City of West Linn
PRE-APPLICATION CONFERENCE MEETING
Notes
November 1, 2012

SUBJECT: Class II Parks Design Review, Historic Landmark, Willamette River Greenway and Flood Management Area permits for construction of a 62 X 33 foot “Carriage House” to be used for summer weddings and similar social functions at the McLean House property located at 5350 River Street.

Proposed Carriage House

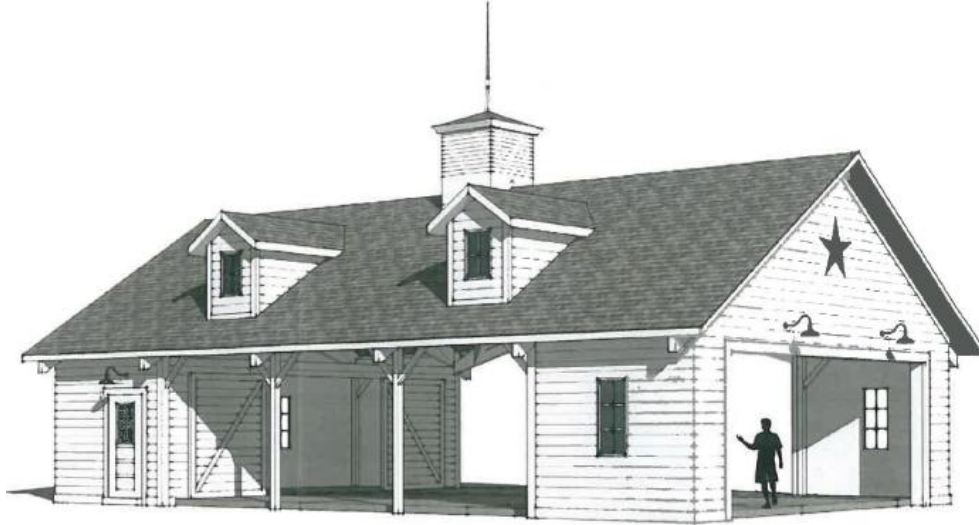
The fact that the historic designation was not based on the site means that some structures could be added to the site without compromising the basis of the historic designation. Staff would underscore the word “some structures” in that it is important that the McLean House maintain its status as the primary or principal structure on this property. By adding a 62 X 33 square foot X 24 foot tall Carriage House, the concern is that its height and size could compete with, or overpower, the principal structure.

Comparing the two structures, the McLean House’s footprint comprises approximately 1,849 square feet while the proposed Carriage House has a footprint of almost 2,046 square feet. Both structures have similar front elevation widths of 61 to 63 feet. The McLean House is two stories and 29 feet tall the Carriage House is just 1.5 stories and 24 feet tall plus an additional five foot cupola. So whereas they both share similar footprints, the taller height of the McLean house ensures that it will maintain its status as the principal structure. Staff also finds that the presence and mass of the Carriage

The Carriage House's 2.5-3:1 height to width ratio of the windows matches period architecture and the proportions of the McLean House's windows. Windows will also be broken into multiple lights to match the McLean House. The dormers on the carriage house provide visual interest and relief from the large roof area.

At the pre-application conference it was stated that the large openings on three sides of the Carriage House would have sliding doors to enclose the interior space. This would help attenuate noise and/or allow the building to be used year round. The design of those sliding doors, which will occupy a large part of the three elevations, will need to be reviewed. Staff's concern is that they could create blank wall elevations unless windows or some other detail are introduced to break up the space.

The applicant has also provided a photomontage of the proposed Carriage House (below at right) with the McLean House shown at the left. Based on this representation, the Carriage House's style of architecture, roof pitch, horizontal siding and color choice is complimentary to the principal structure.

McLean House Master Plan (2005)

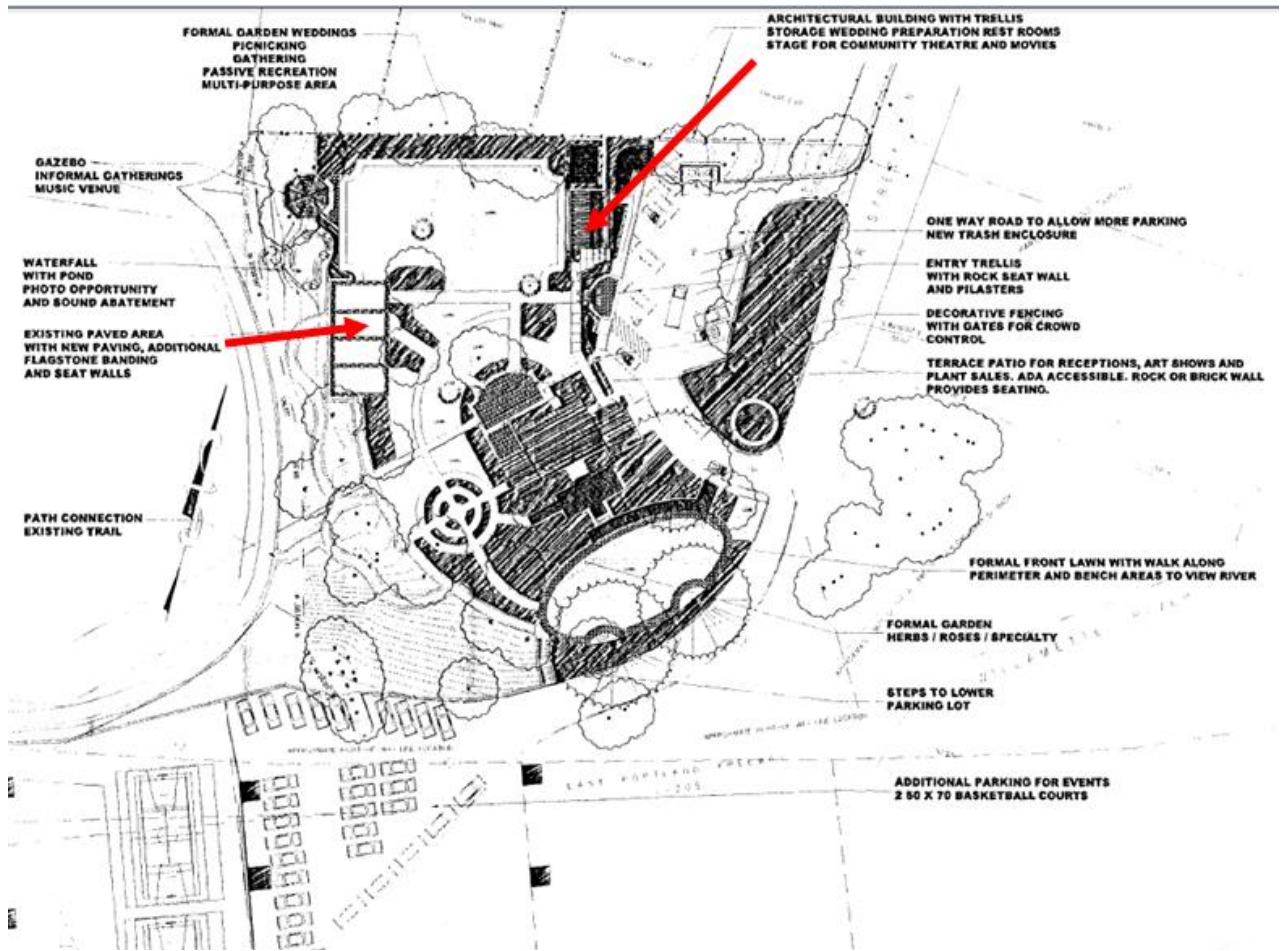
The Parks, Recreation and Open Space Master Plan, adopted in 2007, identifies McLean Park as a “Special Use Area” that is to be developed in the future consistent with the adopted McLean House Master Plan (2005). That 2005 plan envisioned the layout seen below with a new building on the north edge of the site offering rest rooms, storage, wedding preparation, and a stage for movies and a community theater. (This building could be considered as similar to the proposed Carriage House.) The plan also showed a gazebo at the northwest corner. The area being proposed for the Carriage House is shown with minimal improvements in the form of new pavers and no structure.

Although the location of the large accessory structure proposed in the master plan has been moved, staff finds that both locations have similar, potentially adverse, impacts on neighboring homes in terms of noise and glare. What makes the proposed location more attractive is that the Carriage House is pushed behind the McLean House so that it doesn't compete architecturally for attention. In contrast, the 2005 plan's accessory structure was close to the point of access to the site and would have competed with the McLean House. The 2007 Parks Master plan notes that special use facilities should make provision for parking and other functional requirements. The 2005 McLean House plan anticipated that need by showing additional parking on property to the south of the developed park area.

Proposed Carriage House footprint on existing patio area with the neighbors 100 feet away

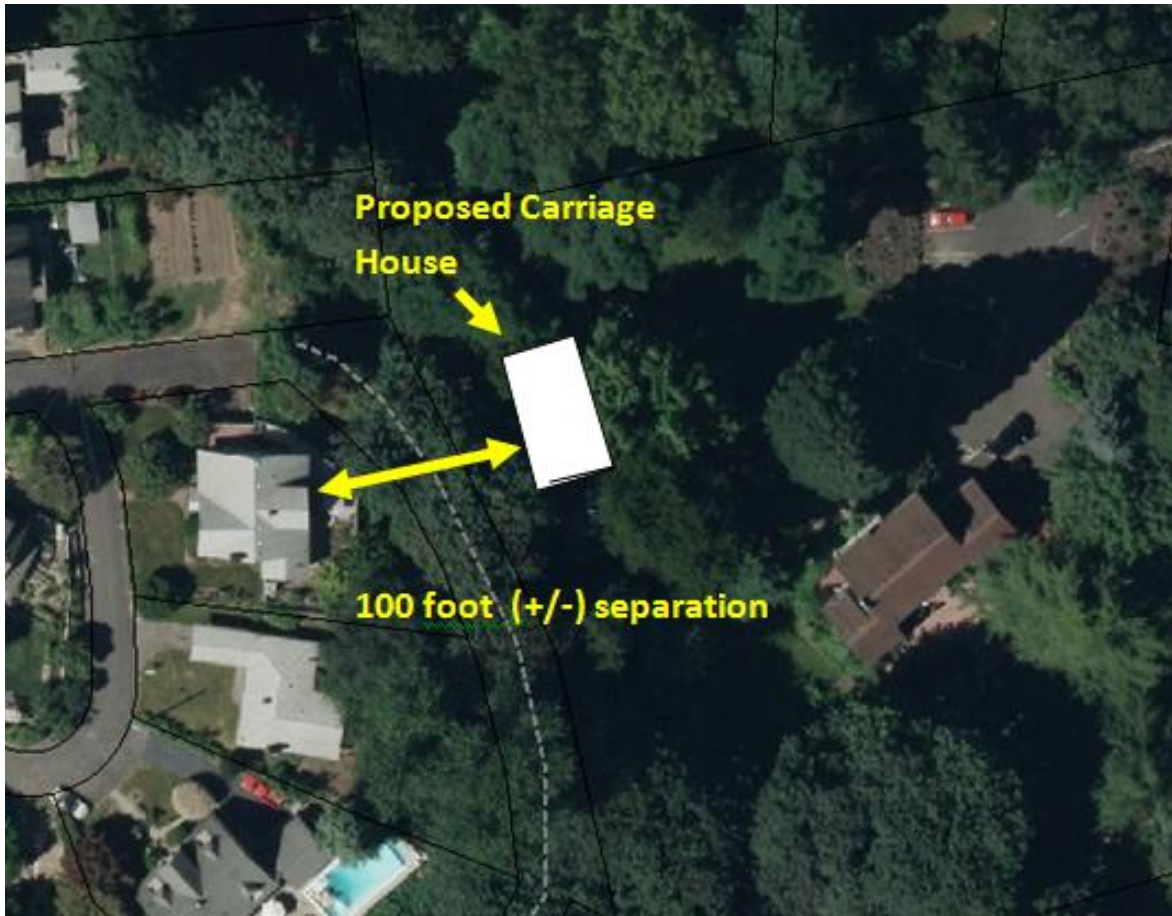
Parks Design Review approval criteria also includes section 56.100(F) "Compatibility between Adjoining Uses". This is an area of concern for staff in that the Carriage House is proposed to be about 100 feet from the back of homes on Grove Street. It is assumed that many of the weddings/social functions will go until 10pm. And, with three of the Carriage House's sides open, it is staff's expectation that noise will impact these homes/homeowners.

At the very least, the applicant should anticipate having to conduct a noise study to demonstrate compliance with Oregon DEQ daytime and nighttime standards. The study would be conducted by an Oregon licensed acoustic engineer.

Glare from the Carriage House and the future parking lot area is also a concern. A photometric study may be required unless the applicant can make a clear demonstration that no off site glare will occur. It should also be noted that the concern about lighting will also extend to potential glare towards the river and associated riparian areas.

Water lines (in blue) with hydrant at the intersection. Two-inch line shown.

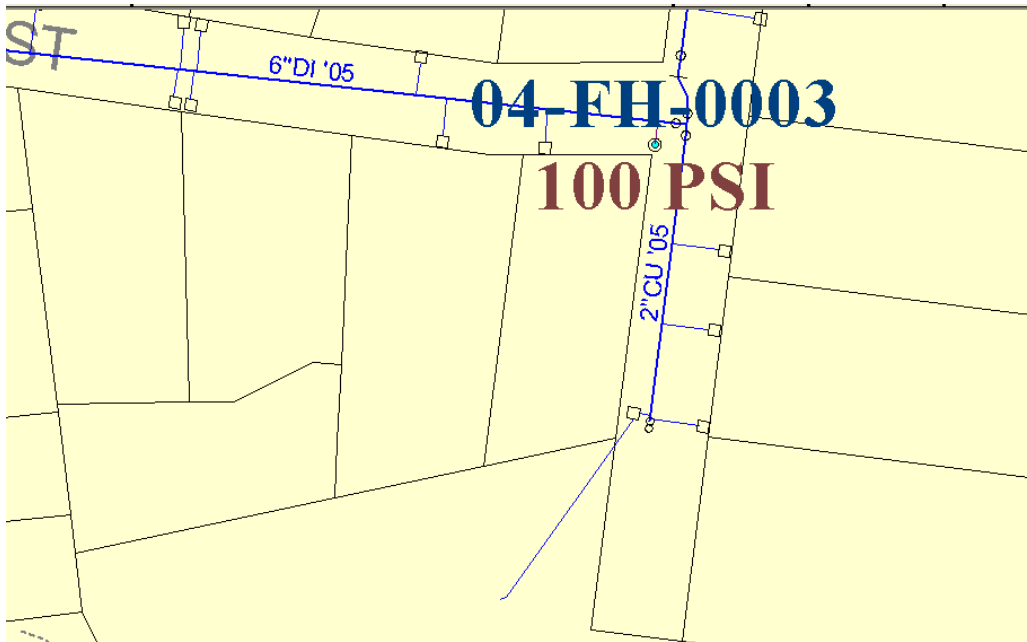
use including water supply. The nearest fire hydrant is at the corner of Holly Street and River Street. The city's GIS map states that there is 100 PSI at the hydrant. The water line from the hydrant to the McLean House is a two-inch line. The applicant will need to demonstrate that the two-inch line will provide adequate fire flow to the proposed Carriage House. **The Tualatin Valley Fire and Rescue (TVFR) contact is Drew DeBois at 503-259-1404 Drew.DeBois@TVFR.com**

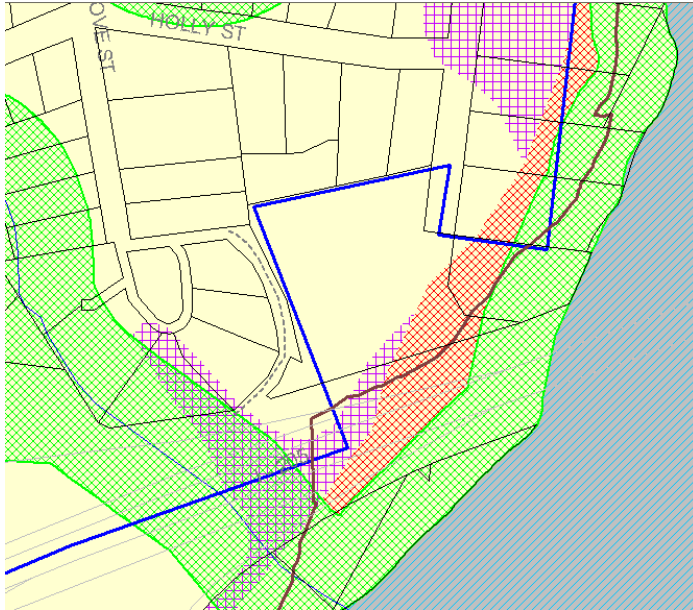
Although the proposed footprint of the Carriage House is also outside of the 1996 flood boundary and the 100-year flood boundary, if the applicant constructs parking and driveway improvements in the area south of the McLean House and inside the boundaries of the McLean House property, a WRG permit and Flood Management Area (FMA) permit would very likely be required since most of those areas are in the high/moderate HCA and/or in the 100 year floodplain and 1996 flood boundary.

Most of the area within the I-205 ROW south of the McLean House Park is in the WRG since it is within a High HCA. (see map above)
